SERVICE BULLETIN

NTB19-022

NISSAN; P0171 AND P0174 SERVICE INFORMATION

FLOW CHART

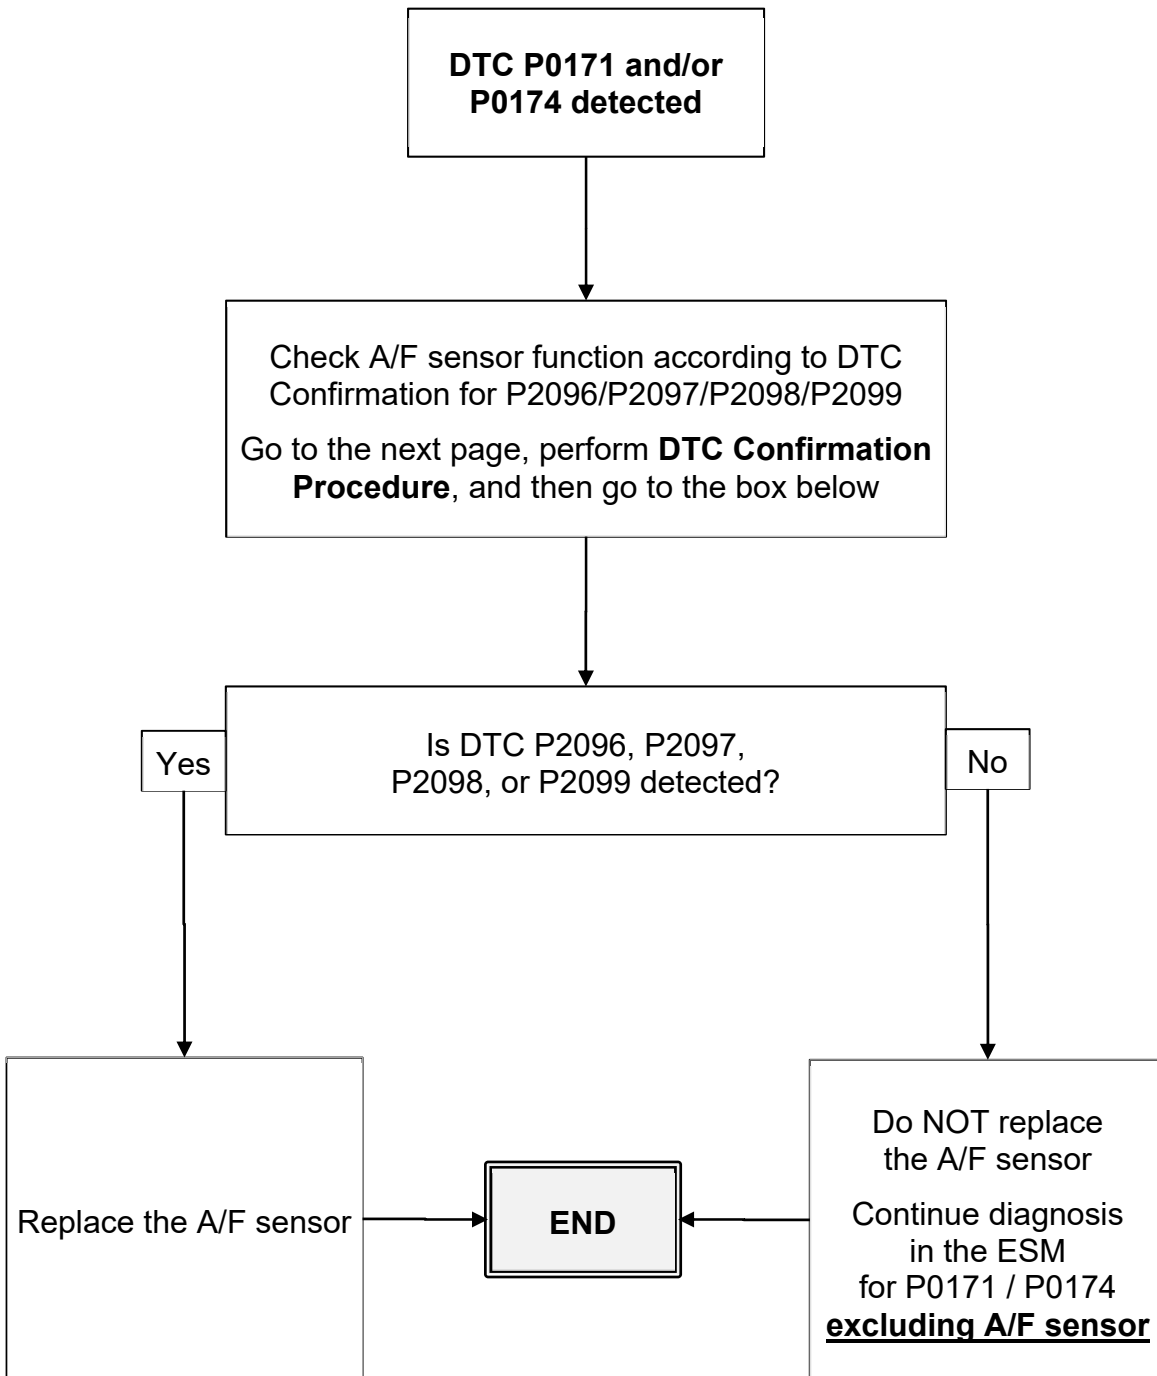
Diagnosis for DTCs P0171 (FUEL SYS LEAN B1) and P0174 (FUEL SYS LEAN B2) have been revised for the **APPLIED VEHICLES** listed above. When performing diagnosis for either of these DTCs, start by using the **SERVICE PROCEDURE** section of this bulletin.

4. Clear the mixture ratio self-learning value:
 - a. Connect the CONSULT PC and plus VI to the vehicle.
 - b. Open CONSULT-III plus (C-III plus).
 - c. Start the engine and warm it up to normal operating temperature.

- d. Go to **WORK SUPPORT**, and then select **SELF-LEARNING CONT.**
 - e. Clear mixture ratio self-learning value by selecting **CLEAR**.
5. Turn the ignition switch OFF and wait at least 10 seconds.

6. Turn the ignition switch ON.
7. Turn the ignition switch OFF and wait at least 10 seconds.
8. Start the engine and keep the engine speed between 3,500 and 4,000 RPM for one (1) minute under no load.

9. Let the engine idle for 1 minute.
10. Keep the engine speed between 2,500 and 3,000 RPM for 20 minutes.
11. Check for 1st trip DTC:
 - If DTC P2096, P2097, P2098, or P2099 is stored, replace the corresponding A/F sensor.

- If no DTCs are stored, continue with the diagnosis in the ESM for P0171 / P0174 **excluding A/F sensor**.
